RHODE ISLAND DEPARTMENT OF TRANSPORTATION

RHODE ISLAND CONTRACT NO.2015-CT-008

**Route 102 at Route 117 Coventry Roundabout (HRRR)**

ADDENDUM NO. 1 Prospective bidders and all concerned are hereby notified of the following changes in the Plans, Specifications, Proposal and Distribution of Quantities for this contract. These changes shall be incorporated in the Plans, Specifications, Proposal and Distribution of Quantities, and shall become an integral part of the Contract Documents.

1. Sheet No. 11 General Plan 2

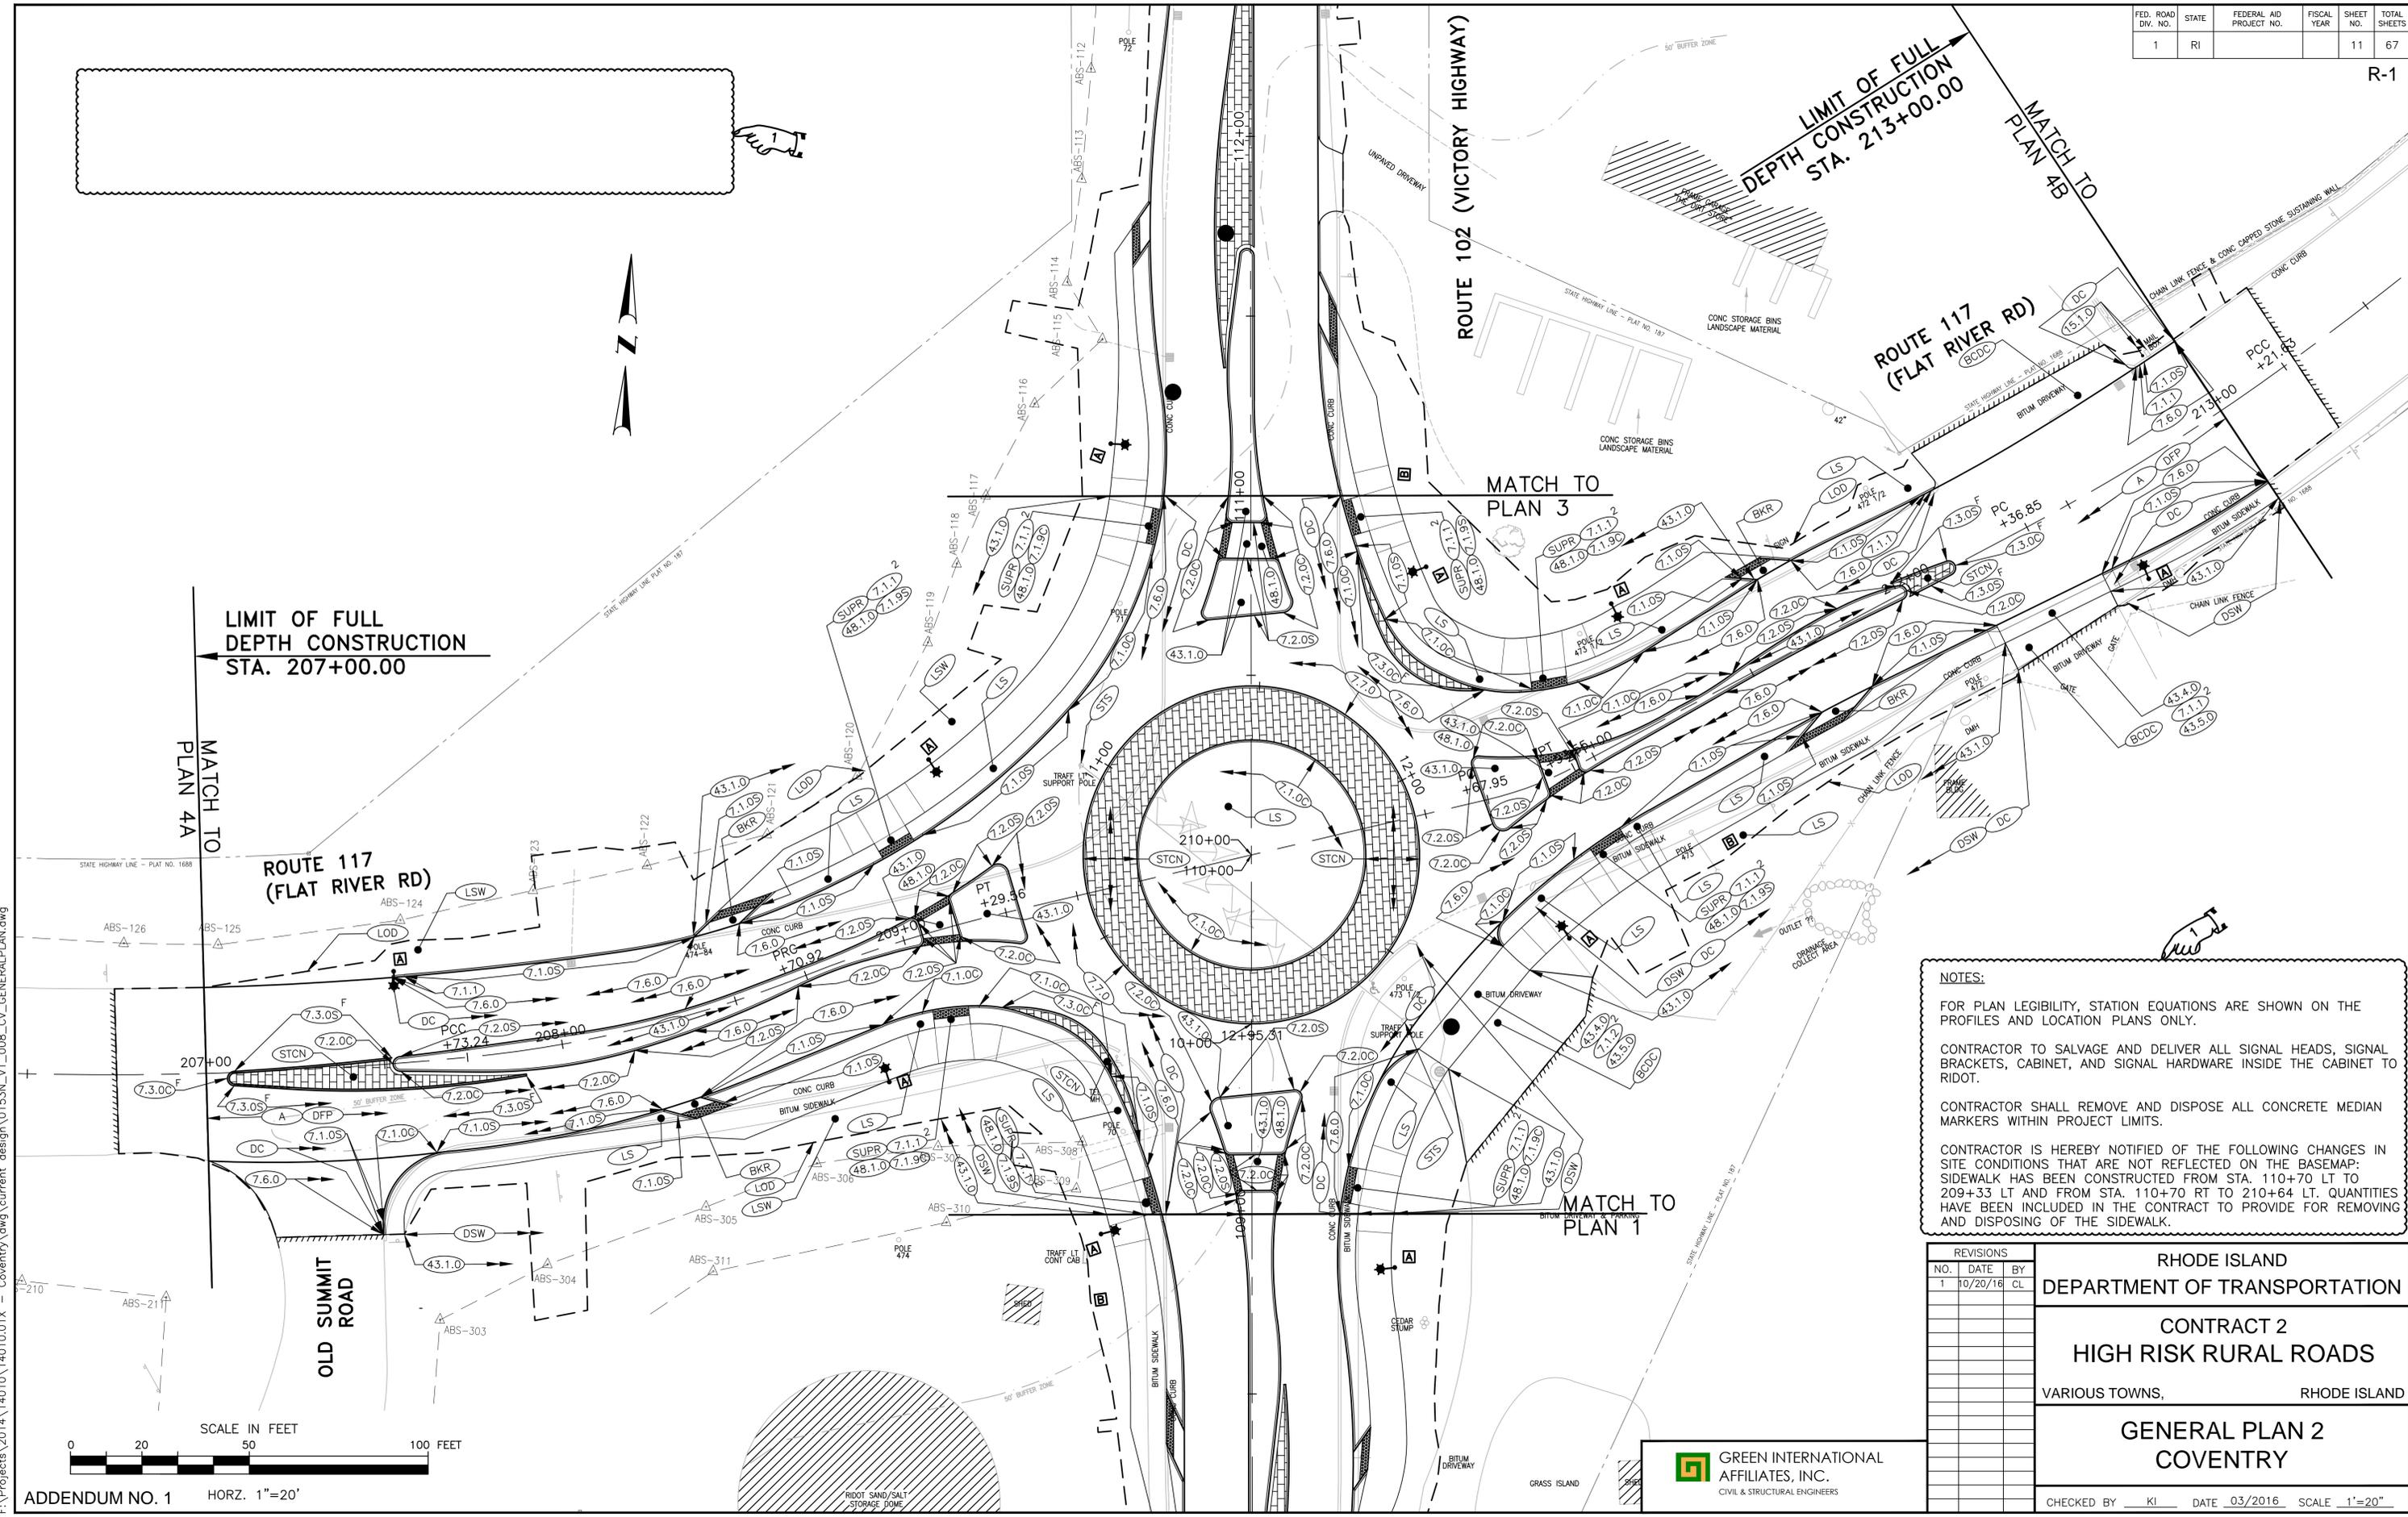
Delete Sheet No. 11 in its entirety and replace with the revised Sheet No. 11 (R-1), attached to this Addendum No. 1. Previous notes have been consolidated into one area of the sheet and an additional note has been added.

CONTRACTOR IS HEREBY NOTIFIED OF THE FOLLOWING CHANGES IN SITE CONDITIONS THAT ARE NOT REFLECTED ON THE BASEMAP: SIDEWALK HAS BEEN CONSTRUCTED FROM STA. 110+70 LT TO 209+33 LT AND FROM STA. 110+70 RT TO 210+64 LT. QUANTITIES HAVE BEEN INCLUDED IN THE CONTRACT TO PROVIDE FOR REMOVING AND DISPOSING OF THE SIDEWALK.

DRAINAGE & UTILITY PLAN 2  
COVENTRY

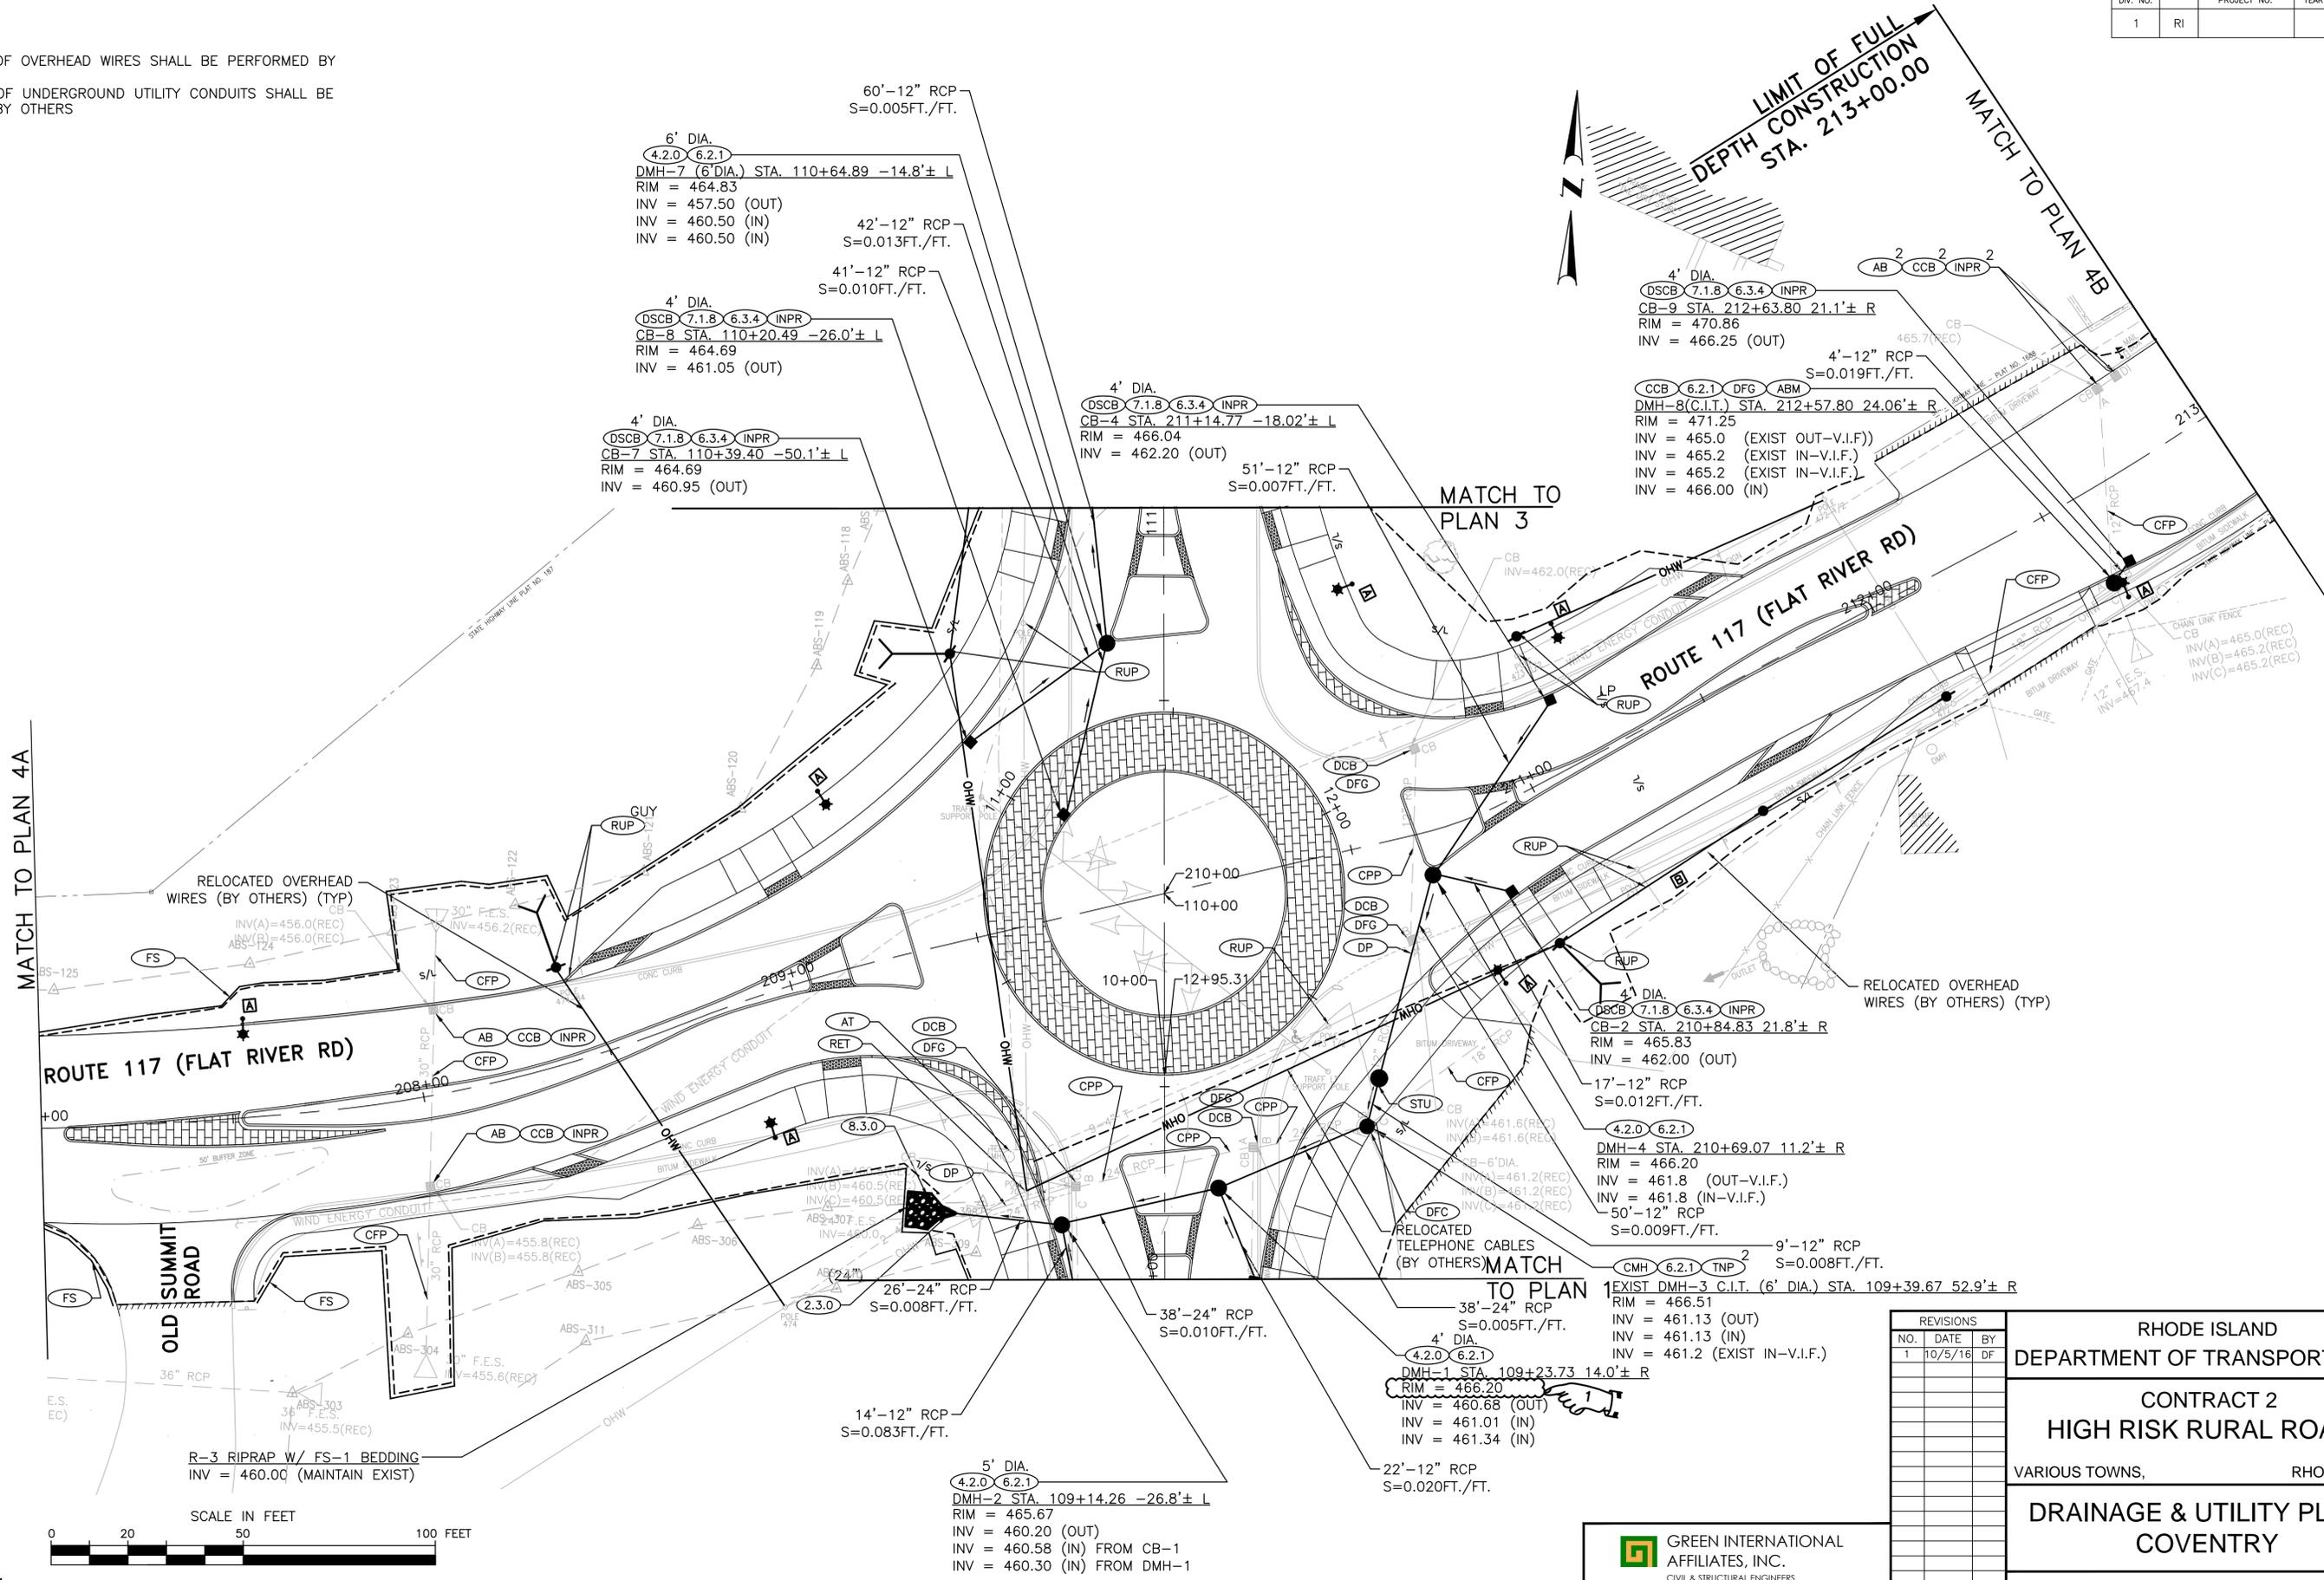
Delete Sheet No. 23 in its entirety and replace with the revised Sheet No. 23 (R-1), attached to this Addendum No. 1. The rim elevation for the proposed drainage manhole DMH-1 at Station 109+23.73 RT has been revised.

Delete Sheet No. 24 in its entirety and replace with the revised Sheet No. 24 (R-1), attached to this Addendum No. 1. The proposed drainage layout has been revised.

CONTRACT 2 <b>HIGH RISK RURAL ROADS</b>	
VARIOUS TOWNS,	RHODE ISLAND
<b>SIGNING &amp; STRIPING PLAN 2</b>	
<b>COVENTRY</b>	
CHECKED BY	DATE
KI	03/2016
SCALE	1"=20'

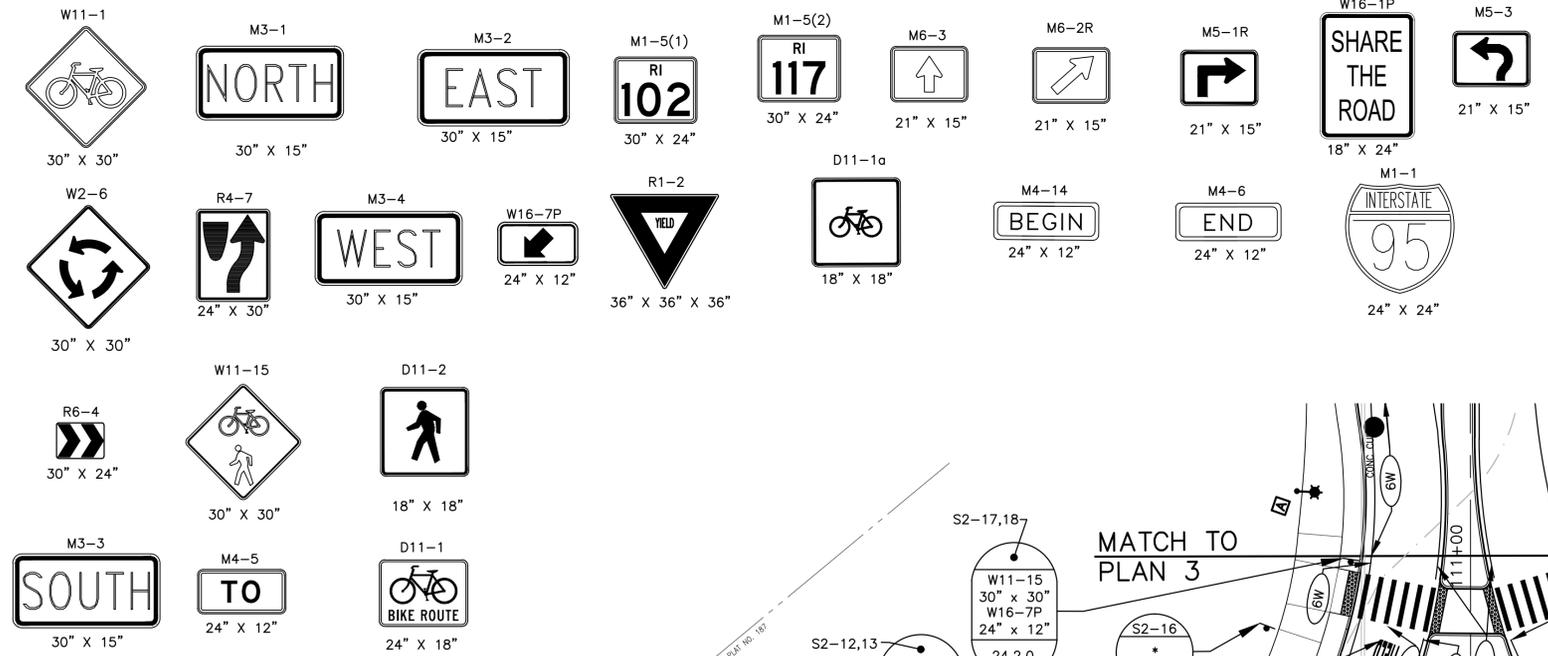
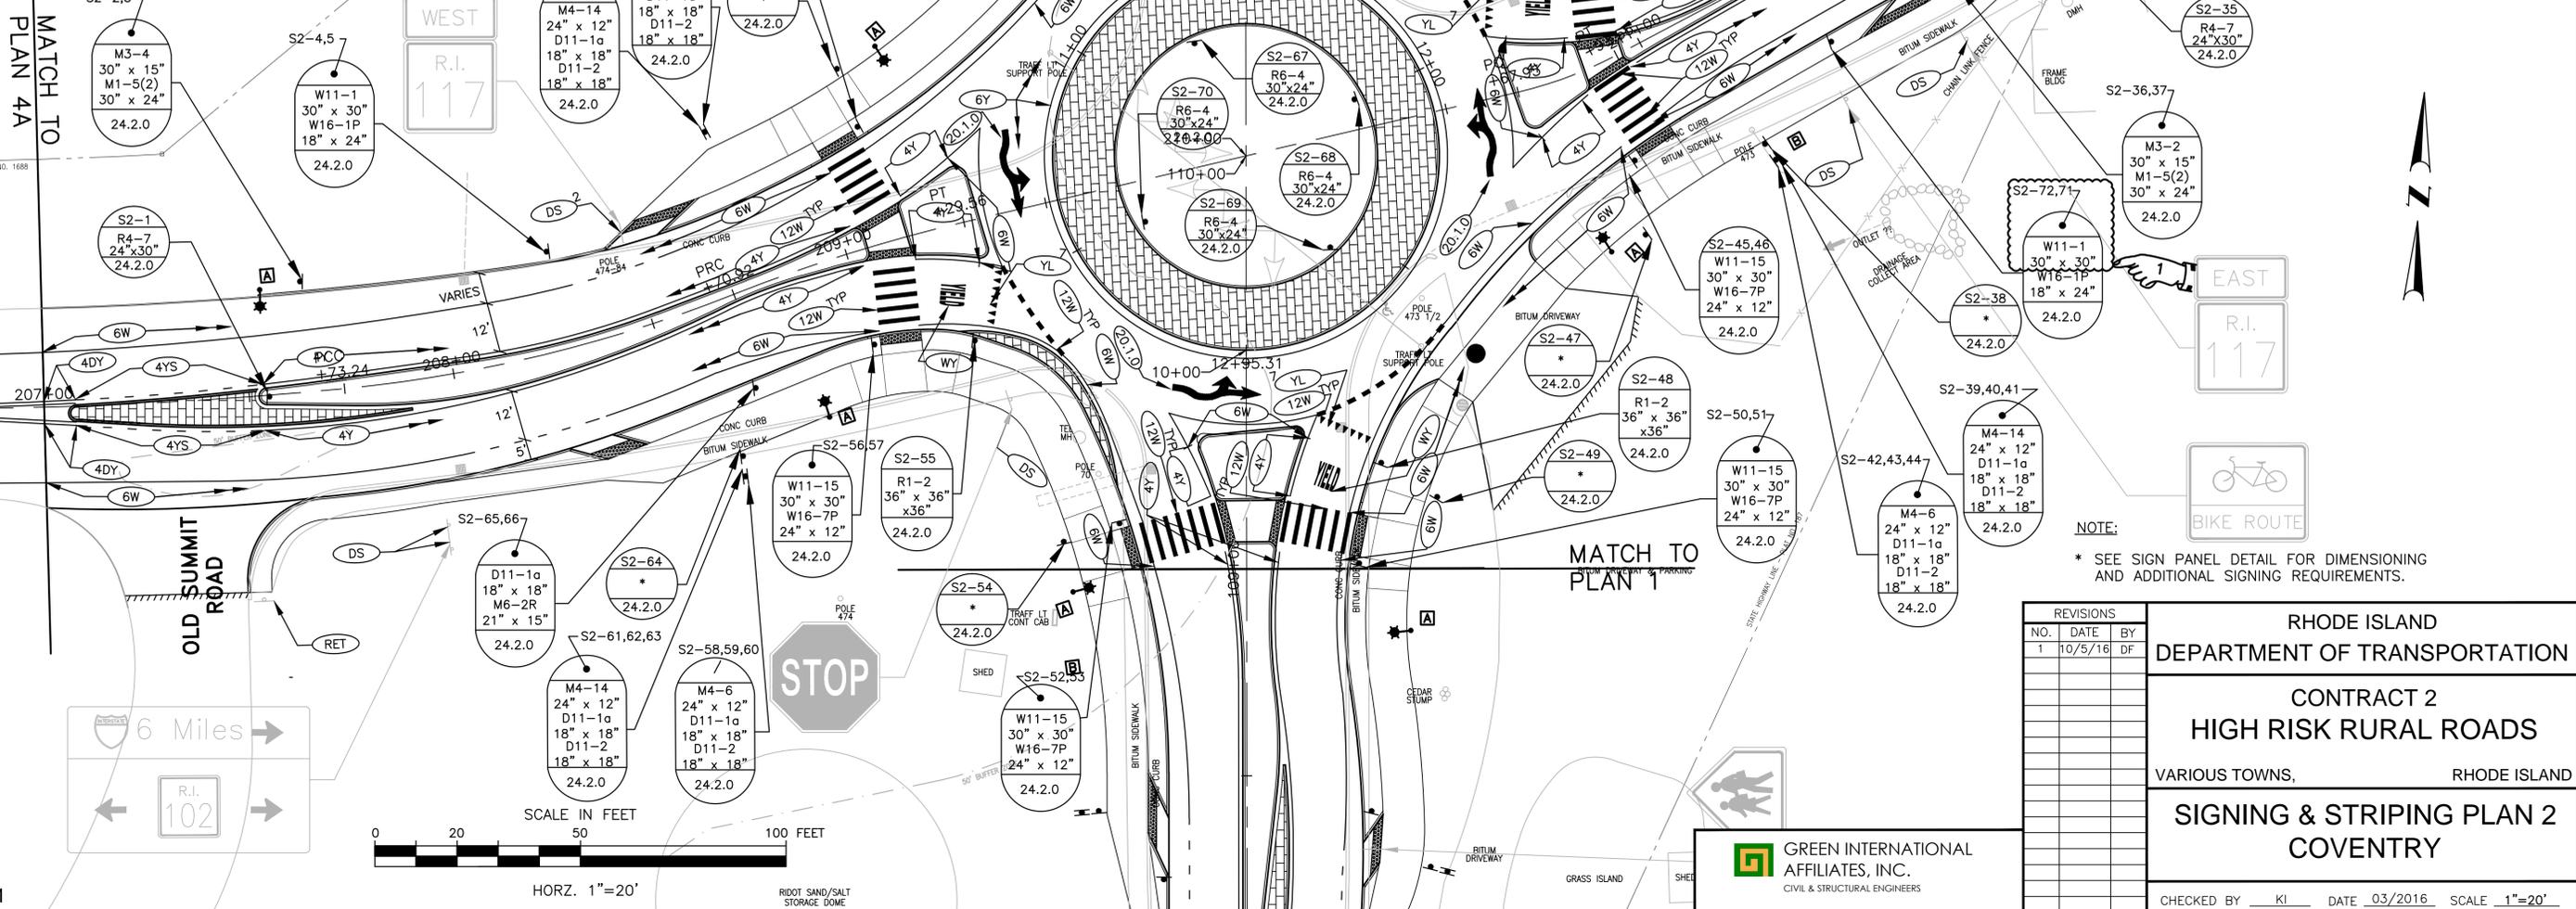
Delete Sheet No. 35 in its entirety and replace with the revised Sheet No. 35 (R-1), attached to this Addendum No. 1. The duplicate S2-70 signs have been revised. Sign S2-70 remains R6-5 at Station 209+73 RT. The duplicate S2-70 sign, W11-1 at Station 211+42 RT, has been renumbered as S2-72.
